## Clause 55 (Rescode) Assessment

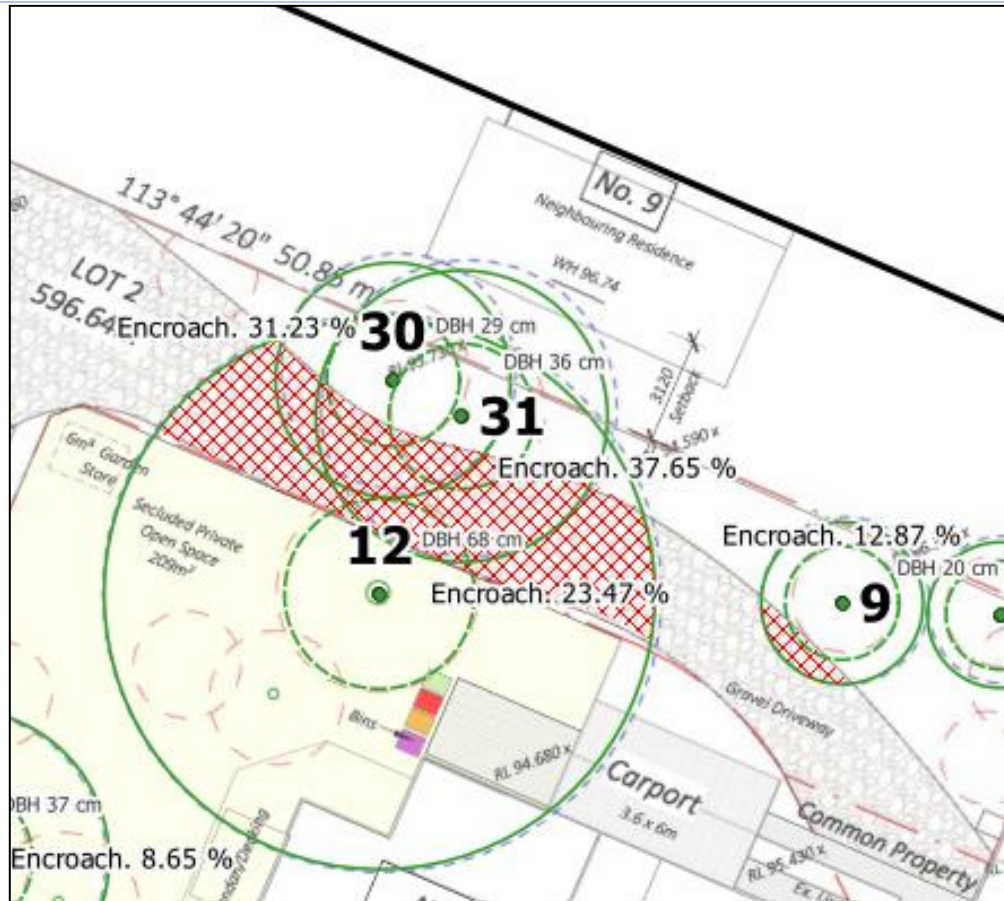
Standard B13	Comments – Standards and Objectives	Met <input checked="" type="checkbox"/> Not Met <input type="checkbox"/>
	<p>Complies with conditions –</p> <p>The proposal will involve the removal of twenty (20) trees from the subject site however only a limited number of those are considered substantial vegetation species. Of the twenty (20) being removed only one (1) are substantial but is exempt from a permit required as it is within 2m of a boundary.</p> <p>The Soft Tree Fern (<i>Dicksonia antarctica</i>) which is proposed for removal can be transplanted and this secured by way of condition.</p> <p>There are four (4) trees which require tree protection measures in order to have the best chance of survival. Those are Trees #9, 12, 30 and 31 which are a Japanese Maple (<i>Acer palmatum</i>), Kurrajong (<i>Brachychiton populneus</i>), Weeping Bottlebrush (<i>Callistemon viminalis</i>), and a Snow in Summer (<i>Melaleuca linarifolia</i>). Tree protection zones of these trees will be encroached by 12.9 percent, 23.5 percent, 31.2 percent and 37.6 percent respectively. However driveway sensitive construction can allow adequate protection for the trees.</p> <p>The application is accompanied by a Concept Landscape Plan. The landscape plan shows the setbacks afforded between the proposed dwelling and property boundaries would allow for planting of one canopy tree (<i>Acacia pycnantha</i>) within the side yard area in along the south side boundary, the landscape plan is deficient in detail and will have a condition to be amended.</p> <p>Should a planning permit be granted, several conditions will be required for tree protection of driveway impacted trees (driveway sensitive construction), Tree Protection Fencing, Street Tree Protection, Tree Fern Transplantation, Installation of Service, Tree Removal, a full landscape plan, and landscaping undertaken to Council's satisfaction and completed prior to occupation of the second dwelling.</p>

The above figure details a snip from the development plans showing the tree protection zones and accessway encroachment for Trees #9, 12, 30 and 31.

Above figure, showing location of assessed windows.

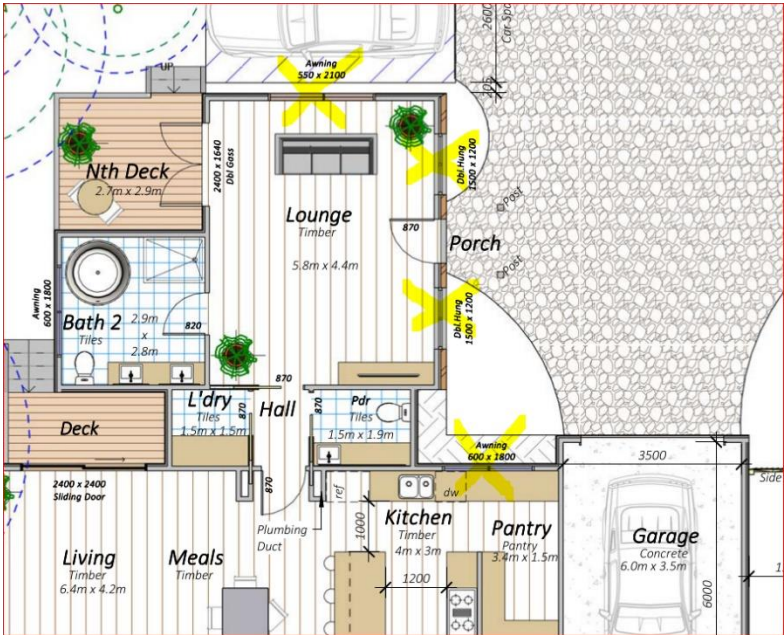
With regard to windows, shared accessways or car parks of other dwellings should be located at least 1.5 metres from the windows of habitable rooms. This setback may be reduced to 1 metre where there is a fence at least 1.5 metres high or where window sills are at least 1.4 metres above the accessway.

Proposed Dwelling (Habitable Window proximity Accessway in to or Car space)	Sill Height (above accessway level)	Required setback from Accessway or Car space (factoring in Sill height)	Actual setback (closest point)	Complies?
North facade: Lounge	1.8 metres	1.0 metre	0.35 metre	No
East facade: Northern most Lounge	0.9 metre	1.5 metres	0.15 metre	No
East facade: Southernmost Lounge	0.9 metre	1.5 metres	0.25 metre	No
North facade: Kitchen	1.5 metres	1.0 metre	1.0 metre	Yes

As can be seen from the assessment table above, the Lounge room window on the north façade, and the northern and southern most windows on the east façade do not meet the standard. In order to determine if the application can vary the standard, the decision guidelines can be considered in this instance.

In considering the design response it is reasoned that the 3 non-complying windows can be treated with double glazing to prevent the transmission of sound and their sill height raised to 1.5 metres as a condition of any approval. 1.5 metres is determined by considering the height of a typical vehicles headlights which range from 700mm-1.2 metres above ground level. The additional 300mm accounts for some light spill. This is considered appropriate and achievable.

The 4 figures above indicate overshadowing between 9am-12midday.

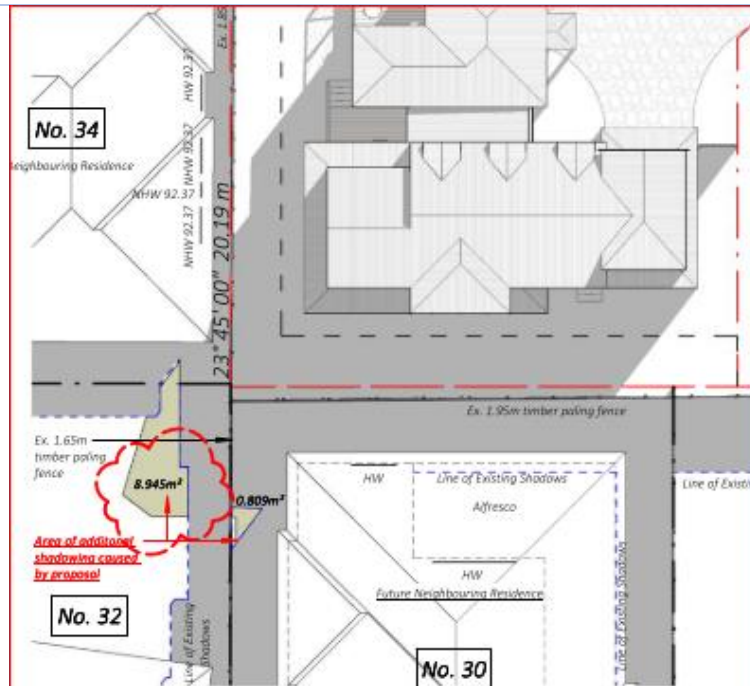
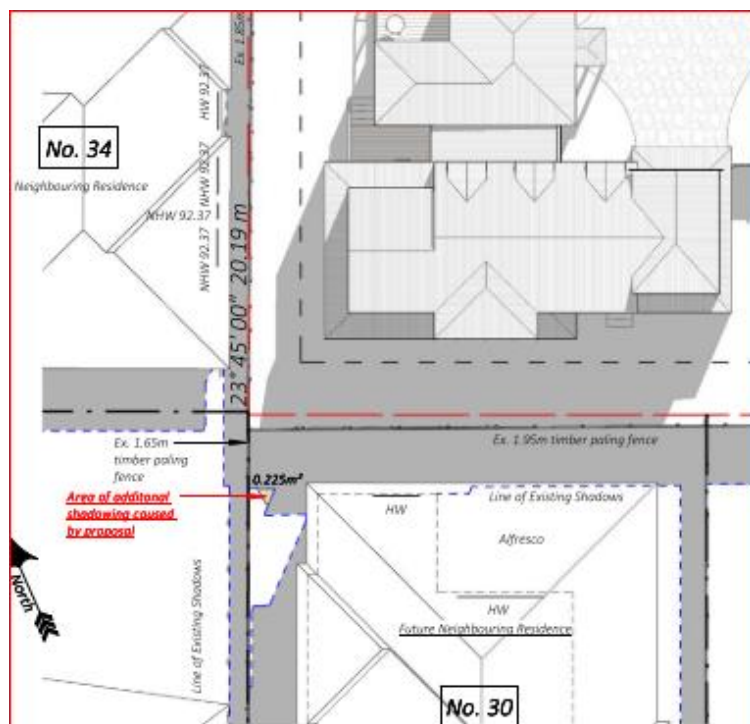
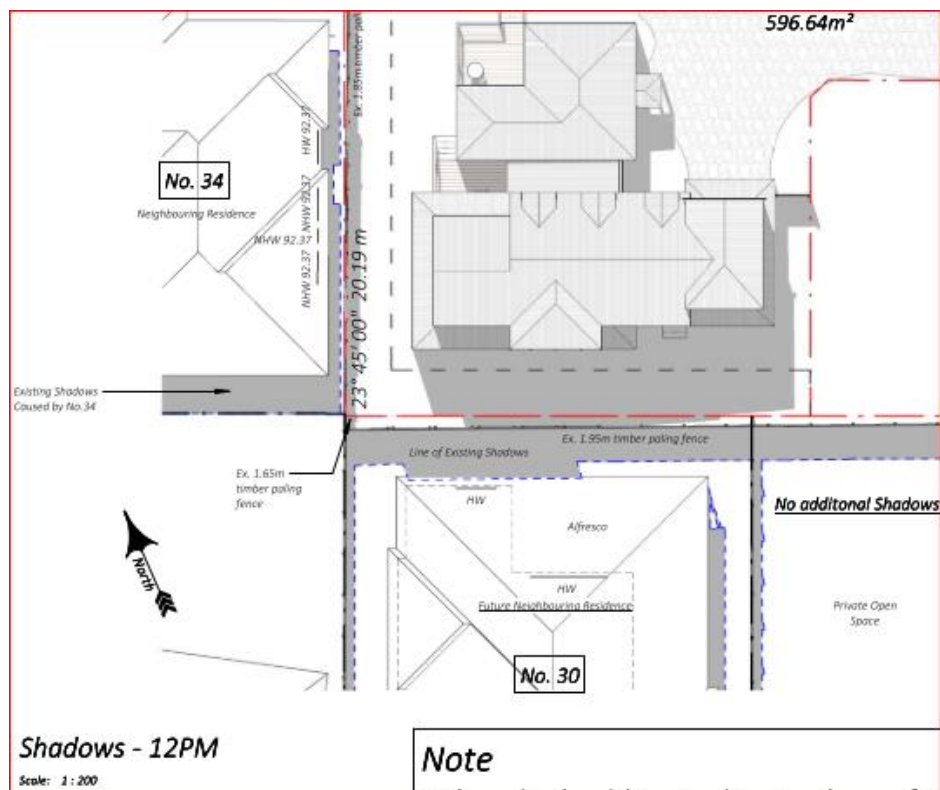
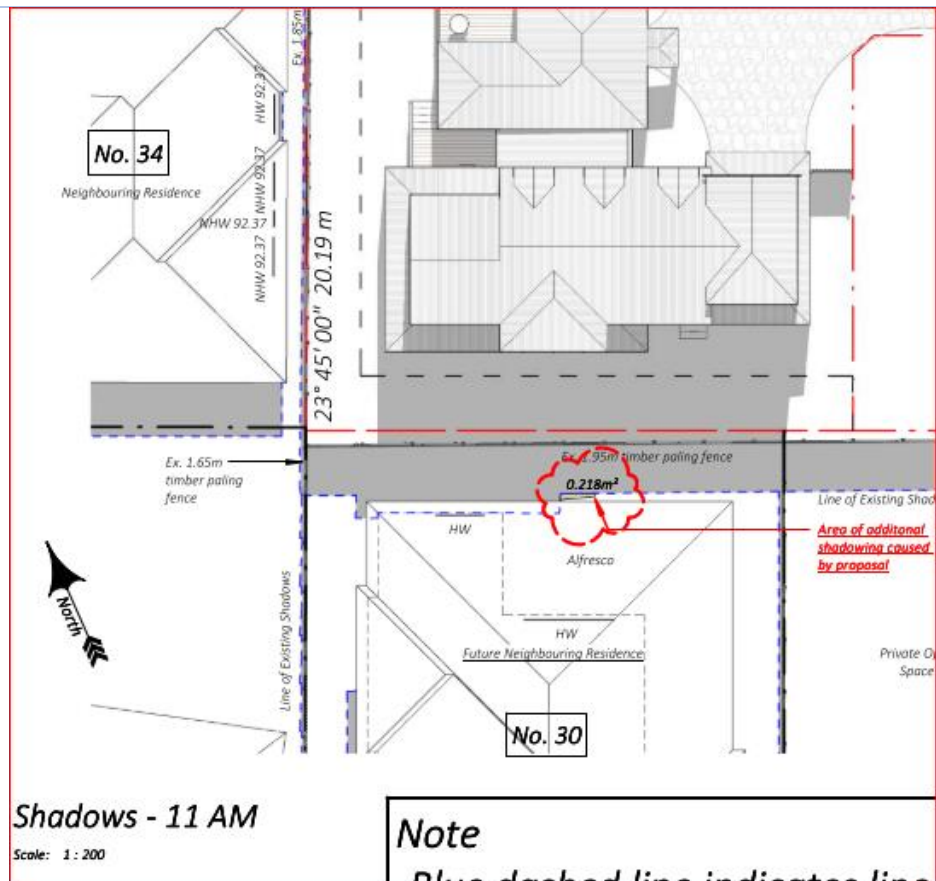
the provision covers existing dwellings only and there is only one affected property to the south of the proposed dwelling at No.30 Harker Street. The site is under construction so its questionable whether this is considered an existing dwelling, however for the benefit of any doubt, an assessment is provided:

Time on 22 September	Quantity of additional land overshadowed inside neighbouring SPOS at 30 Harker Street
9am	0.809 square metres

<b>10am</b>	0.225 square metres
<b>11am</b>	0.218 square metres
<b>12-midday</b>	0 square metres
<b>1pm</b>	0 square metres
<b>2pm</b>	0 square metres
<b>3pm</b>	0 square metres

The Secluded Private Open Space (SPOS) area for 30 Harker Street is 50 square metres (see plan measurements below) but the standard requires at least 75 percent or 40 square metres of SPOS to have solar access between 9am and 3pm. The lesser area in this case is 40 square metres and this is reduced by a total of 0.443 square metres for 5 hours which is within the 50 square metres and greater than the allowable 40 square metres (leaves 49.55 square metres with solar access between 9am-3pm) which is greater than 40 square metres. Therefore, the area of additional overshadowing is to the south outside of the calculated SPOS area is shown to be acceptable in that at least 40 square metres of SPOS area will achieve 5 hours of sunlight between 9am-3pm.

The figure above is taken from the endorsed plan dated 29 May 2024 under YR-2022/881/1 of the secluded private open space area of 30 Harker Street indicating the area calculation as being 50 square metres.

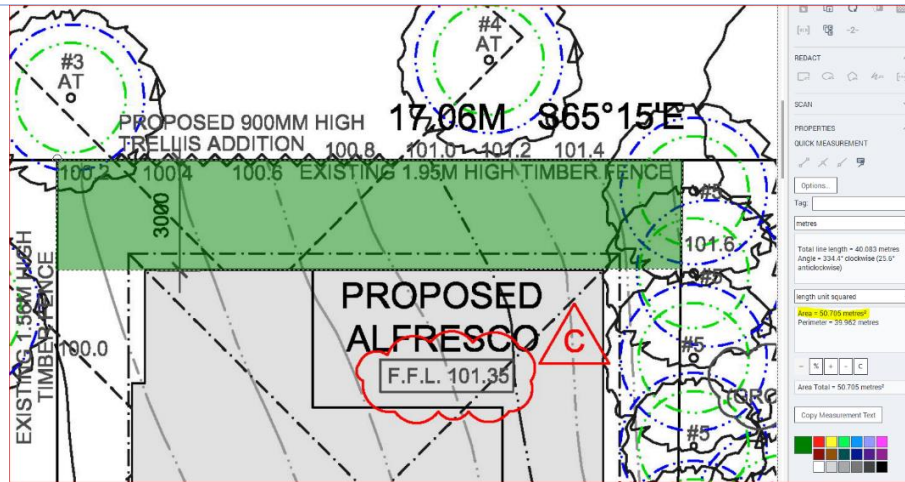
The area of SPOS has been calculated from the endorsed plans from the relevant planning permit YR-2022/881 for 30 Harker Street, approved 22 August 2023 and endorsed amended plans issued 29 May 2024 under YR-2022/881/1. The shadow of the existing fence is not included in the calculations. A snip of the 30 Harker Street site plan is shown below indicating the SPOS area (not identified on the plans) is 50 square metres. Snips of the relevant overshadowing diagrams from 9am, 10am, 11am and 12-midday are also provided below. The overshadowing reduces it by 0.225 square metres at 10am and 0.218 square metres at 11am. However, it is not necessary to include the 9am in the calculation as the 5-hour requirement can span 9am-2pm or 10am-3pm, however I have included it therefore consideration of the broader context.
